**CITY OF MILWAUKIE
PLANNING COMMISSION
MINUTES
Milwaukie City Hall
10722 SE Main Street
TUESDAY, May 11, 2010
6:30 PM**

5.1 Summary: Riverfront Park
Applicant/Owner: City of Milwaukie
File: DR-09-01, TPR-09-03, WG-09-01, WQR-09-01, and VR-09-03
Staff Person: Ryan Marquardt

Milwaukie Riverfront Park

Drawing File: P:\MAEX00000018\040000\DWG\Sheet\PERMIT DRAWINGS\DESIGN REVIEW PACKAGE\Fig2_Proposed_MAE00018.dwg Date/Time: Feb 08, 2010 8:41am User: bar

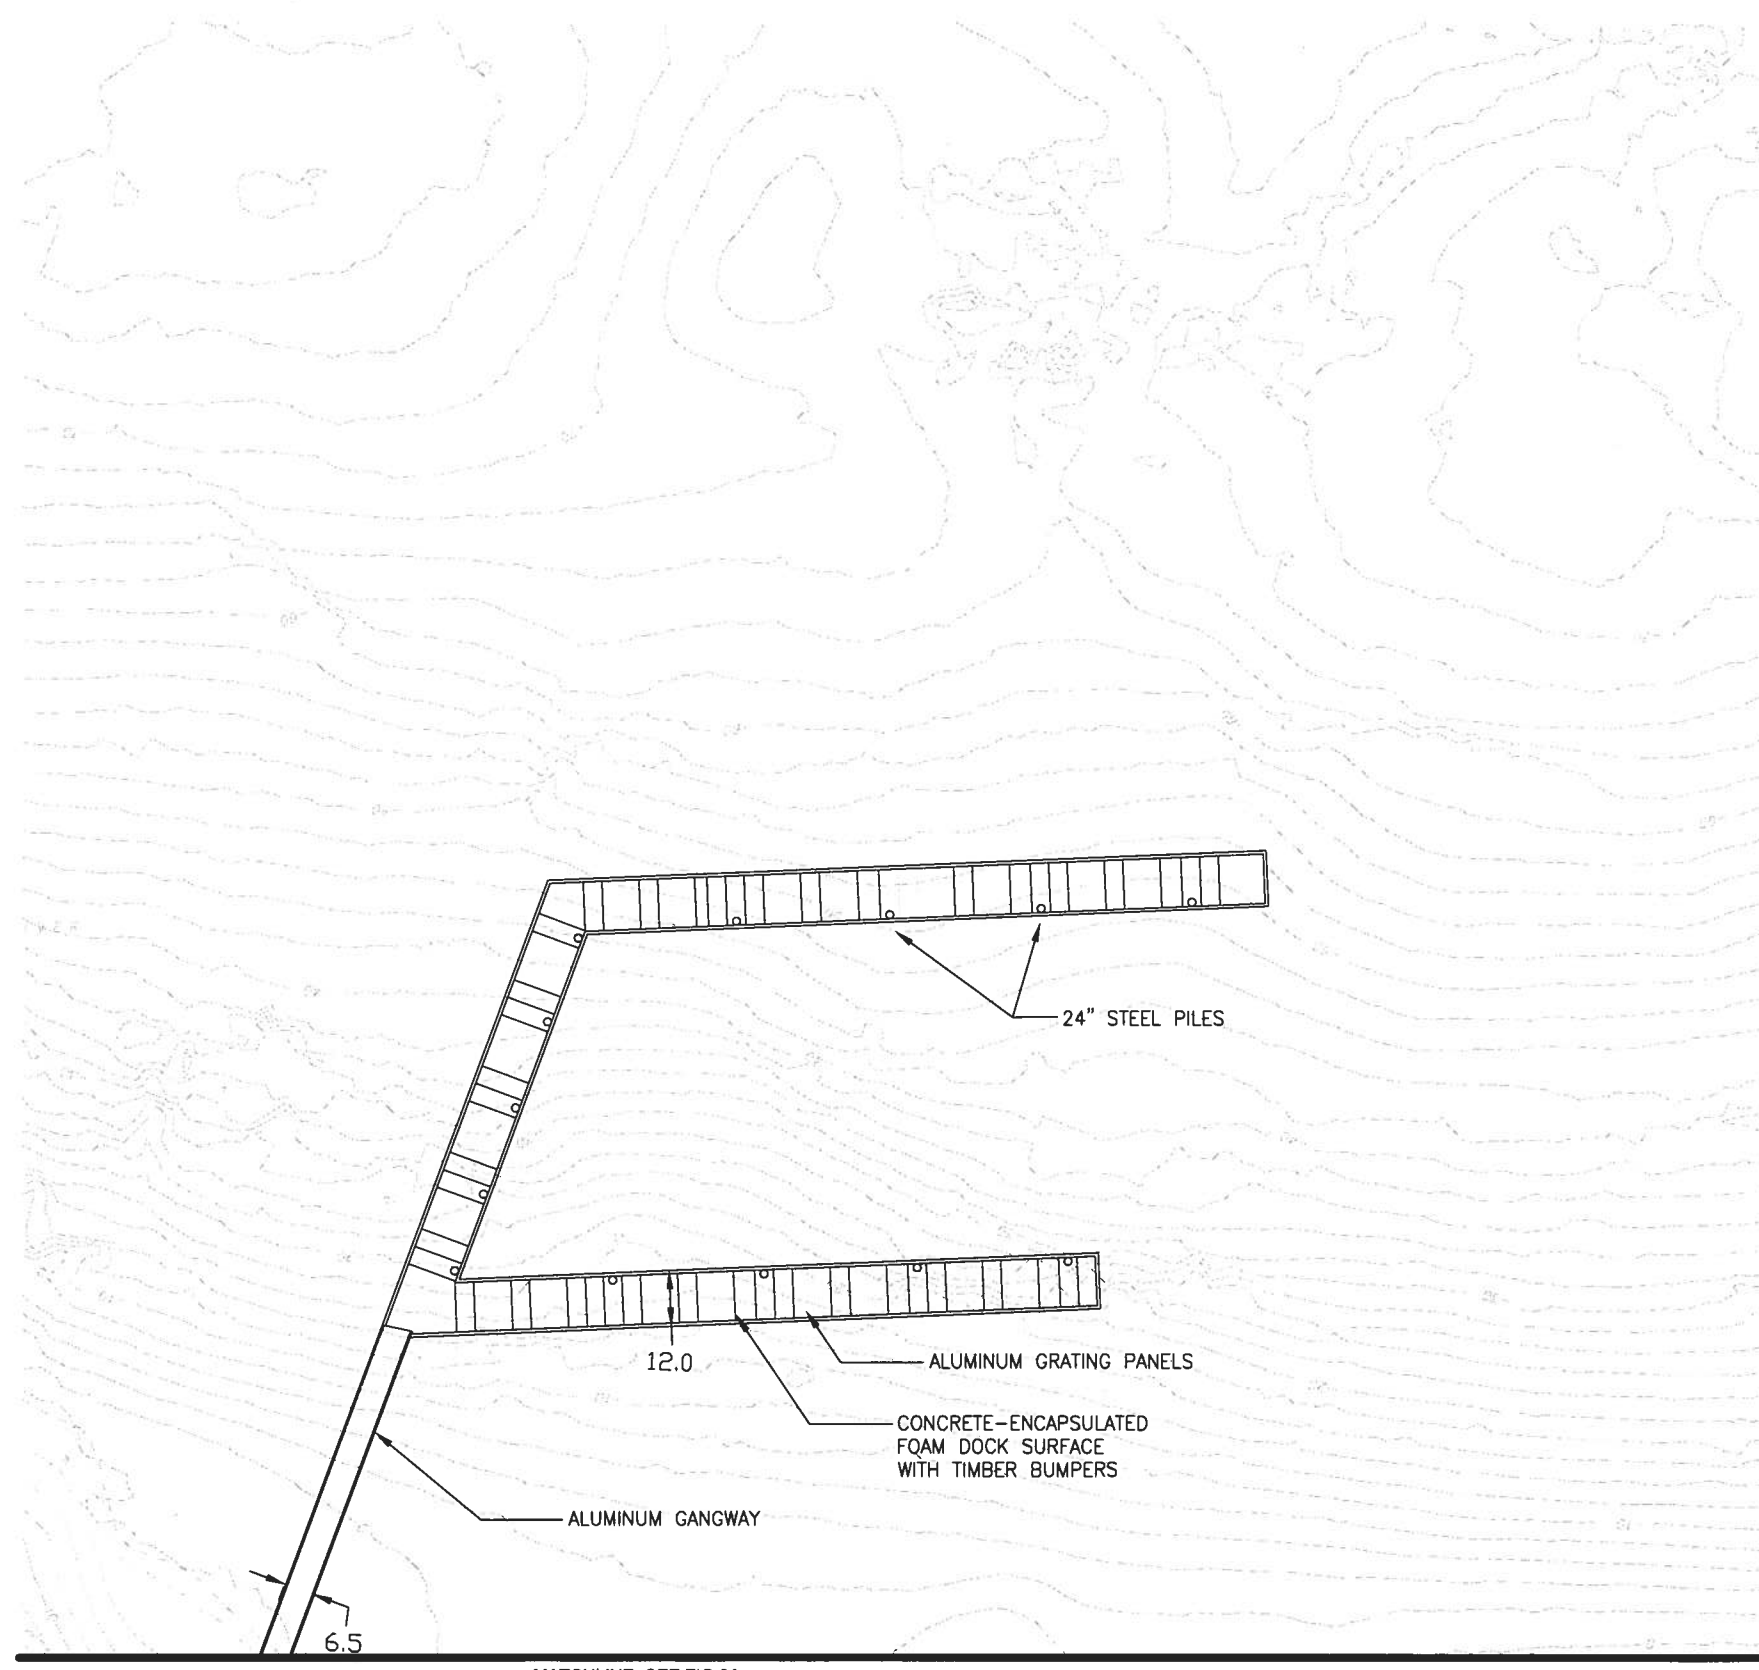
- **Ms. Mangle** responded that the current FEMA flood line was about the same as the 1996 flood line. The City's WQR map used both the FEMA and 1996 flood lines, which did not make a difference in this stretch along the Willamette River. The FEMA 100-year floodplain line was shown on the most recent version of the Park Plan Existing Conditions Maps on page 101 of the Municipal Zoning Code. Figure 2D of the supplemental packet showed a 100-year flood elevation. [also Figures 2, 2A-2C]

FIG 4
JOB NO. MAEX00000018

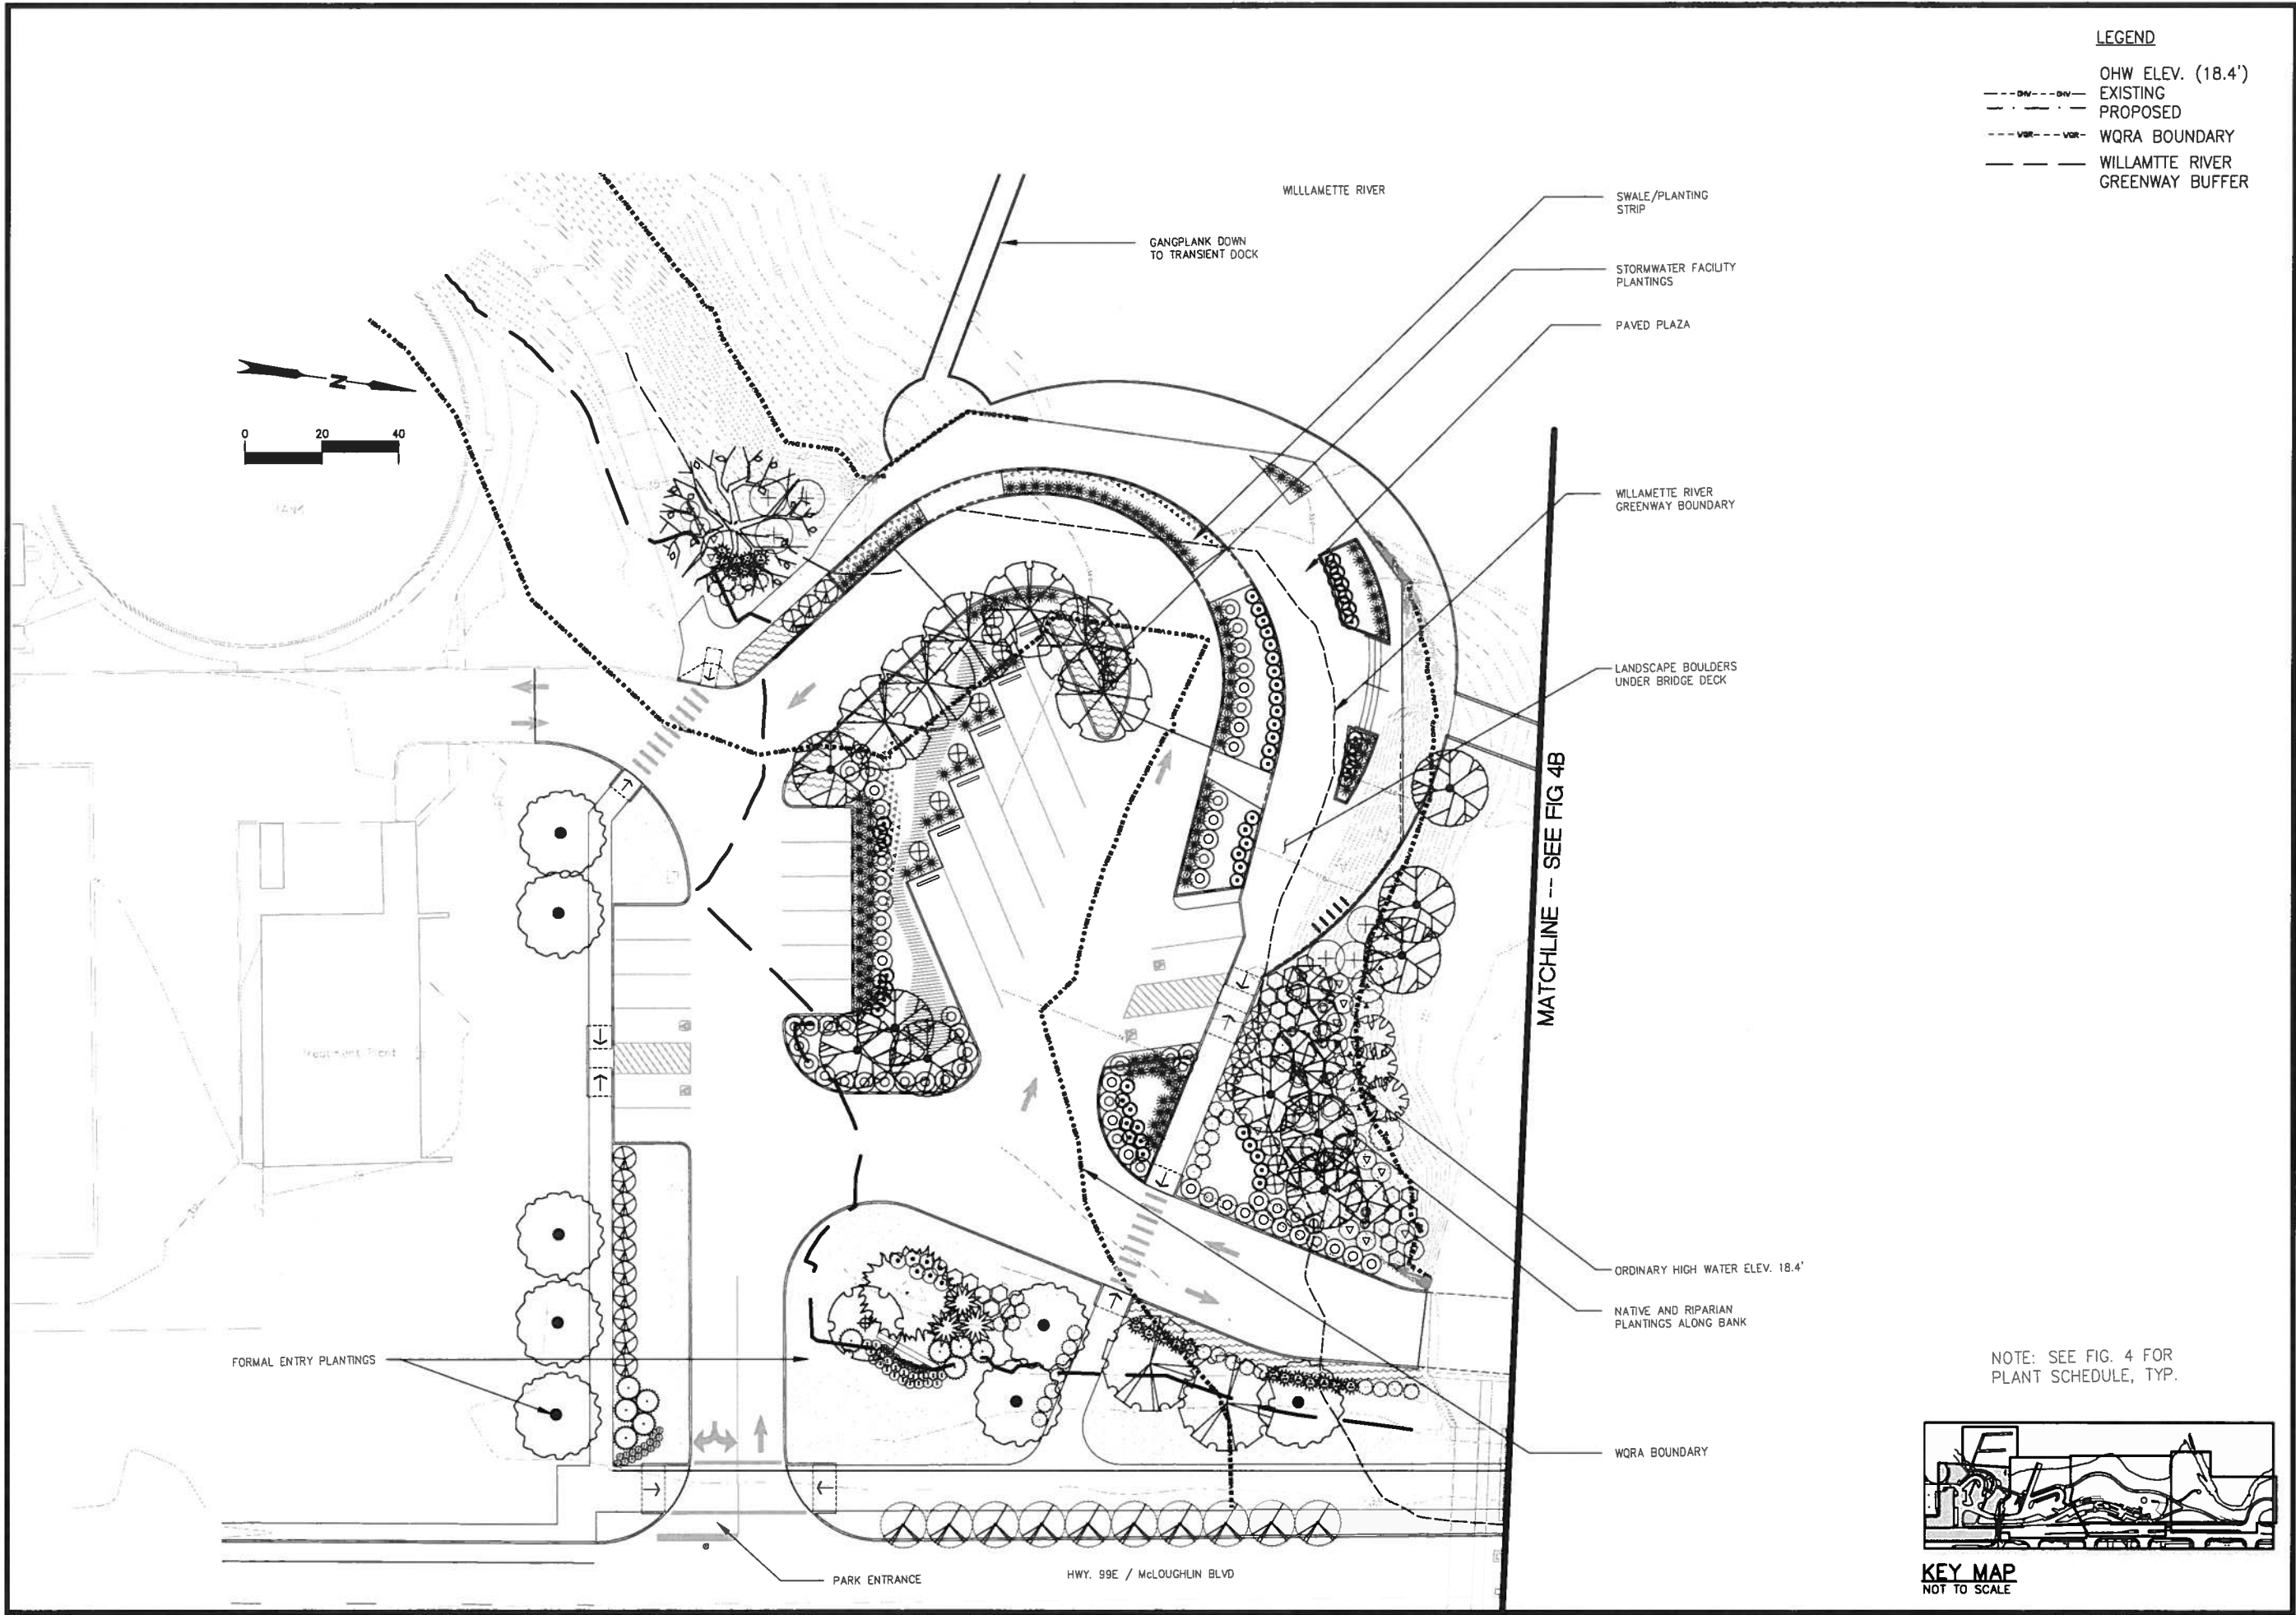
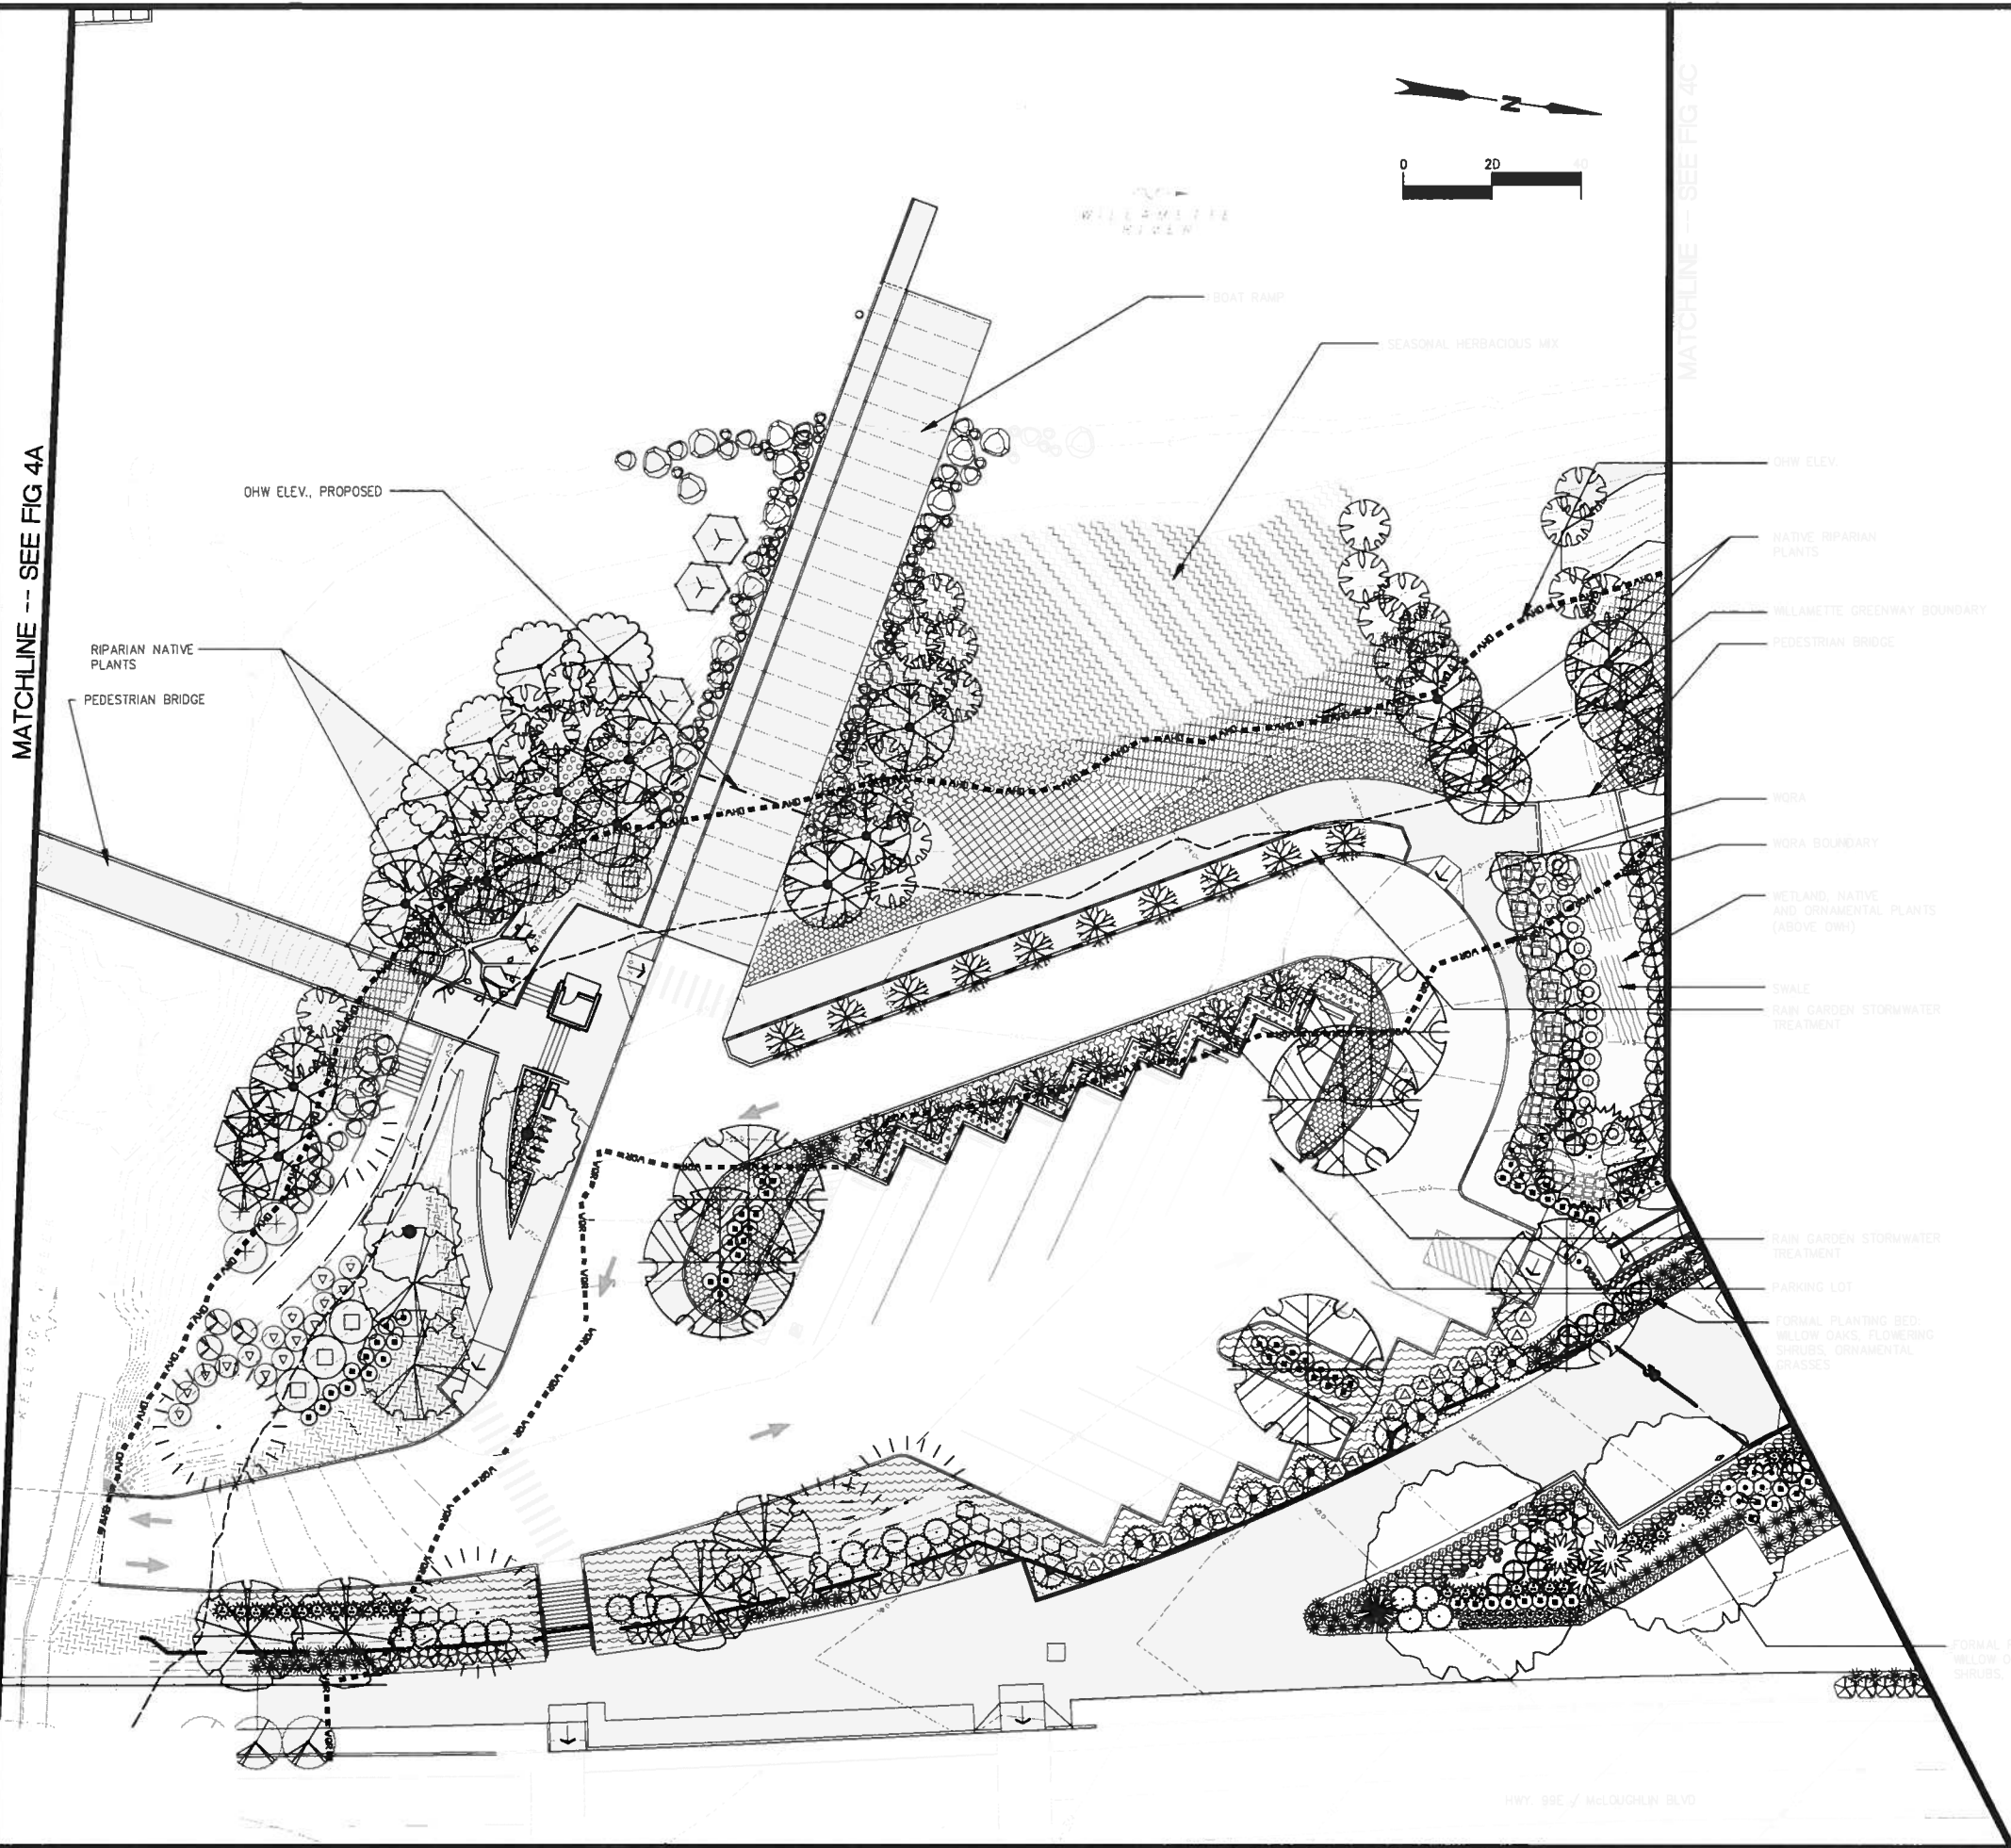
Non-native trees and shrubs are apparently listed for installation within the WQRA on Figure 4 of Appendix B (“Tab” B). We recommend using only native species identified on the Metro native plant list in the WQRA. Metro is currently referencing the City of Portland native plant list while its list is updated: <http://www.oregonmetro.gov/index.cfm/go/by.web/id=27023>. Table 1 lists non-native species apparently designated for installation in the WQRA; and native analogs that could be substituted. Additionally, Figure 4 should list the complete scientific name of all proposed plants, not just the genus in some cases.
- L. Sufficiently addressed.

- H3. The General Site Mitigation Plan and Figures 4, 4A – 4D provided in the supplemental information document (item 1 in the bulleted list above) provide information about mitigation that sufficiently responds to comments provided regarding this requirement.

- I1. Adverse impacts are described in the alternatives analysis documents.
- I2. The General Site Mitigation Plan and Figures 4, 4A – 4D and the alternatives analysis provided in the supplemental information document (item 1 in the bulleted list above) provide information about mitigation that sufficiently responds to comments provided regarding this requirement.
- I3. Sufficiently addressed in the initial application.
- I4. The project is described as “self-mitigating” and a specific mitigation site is not identified.
- I5. The General Site Mitigation Plan and the alternatives analysis provided in the supplemental information document (item 1 in the bulleted list above) provide the requested information.
- J. A stand-alone mitigation plan document is not present. The information that would be included in the mitigation plan is present elsewhere in the application materials.
- K. NA

- K. The General Site Mitigation Plan and Figures 4, 4A – 4D and the alternatives analysis provided in the supplemental information document (item 1 in the bulleted list above) provide information about mitigation that sufficiently responds to comments provided regarding this requirement.
